HORSHAM DISTRICT COUNCIL CONSULTATION

TO:	Horsham District Council – Planning Dept
LOCATION:	Land at Sumners Ponds Chapel Road Barns Green West Sussex
DESCRIPTION:	Application for Approval of Details Reserved by Condition 18 to approved application DC/21/2697
REFERENCE:	DISC/24/0005
RE-CONSULTATION:	1st set of comments in black 2nd set of comments in blue
RECOMMENDATION:	Holding Objection / More Information / Modification Holding Objection / More Information / Modification

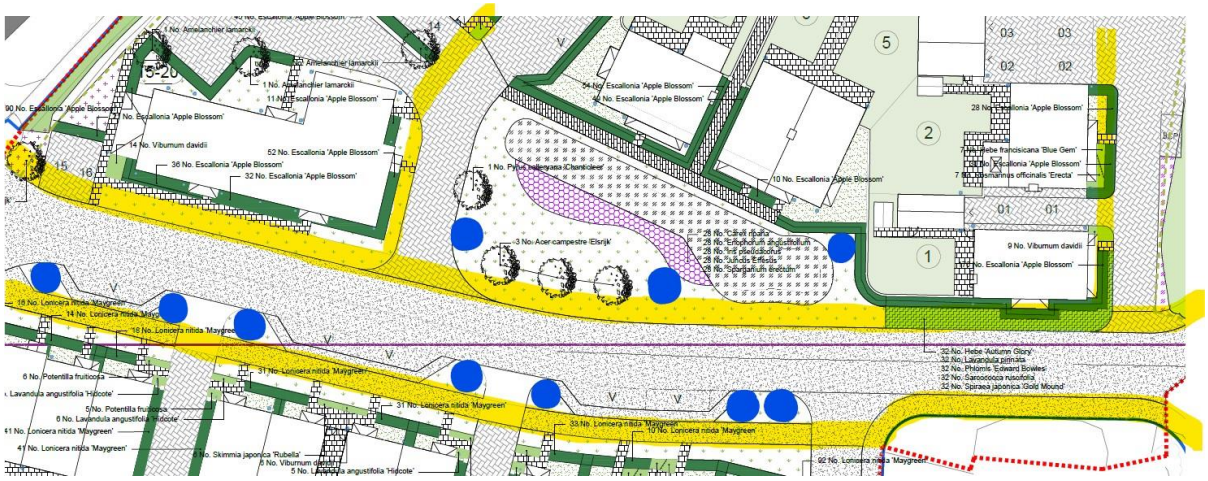
2. It is unclear why a footpath is now indicated to the north of the access which has enormously impacted on the design vision for a tree-lined entrance route. There remains opportunity to provide further tree planting to the north of the northern service route as well as to the north of the southern service route, as previously approved under DC/21/2697. Please image below for indicative tree locations in blue and service routes in yellow:

Hard Landscape

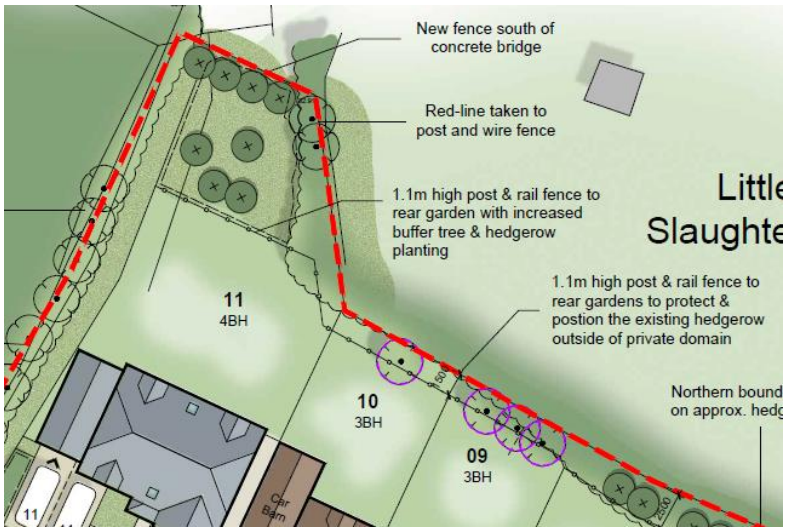
17. Application stage considered an appropriate coloured asphalt, has this been discussed? Closed.
18. Please add secure cycle storage location and refuse/recycling facilities for the apartment block to plan. Closed.
